# **Oakland Harbor Turning Basins Widening**

Revised Draft Integrated Feasibility Report and Environmental Assessment

### **Response to Public Comments**

#### **Comments #63 - 94**

EXHIBIT B

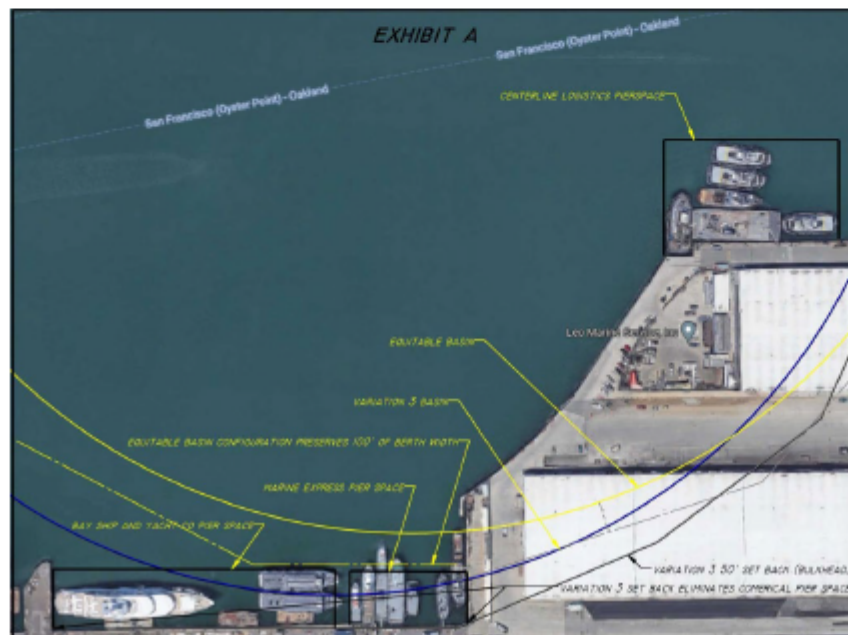
Unfortunately, the Tentatively Selected Plan ("TSP") for expansion of the Inner Harbor Turning Basin significantly impacts Bay Ship's ability to operate effectively. This impact is caused by the decision to shift the turning basin further into the City of Alameda. This impact can be dramatically reduced, if not eliminated altogether, by simply shifting the basin further into Oakland. The impacts of the current design result from the decision by the USACE to minimize the loss of land in Oakland at the expense of taking more land located in the City of Alameda. But by making the adjustment shown below, in a manner that more equally shares the project impacts to the two cities, the impacts to Bay Ship's business will be minimized.

Exhibit A below shows the impact to Bay Ship and Yacht from the current project proposal. Exhibit B shows how a slight shift in the project design significantly minimizes/avoids the impact to Bay Ship. Larger versions of these exhibits appear at the end of the letter.

69	See Appendix B2 Geotechnical Engineering for additional descriptions and explanations of side slopes and buffers. The adjusted alignment should limit impacts to Bay Ship, as stated in this comment letter. Project grading and bulkhead wall configuration have not yet been finalized. USACE generally concurs that a buffer may be feasible in lieu of a 3:1 (H:V) slope in areas where a bulkhead wall is constructed.	Appendix B2
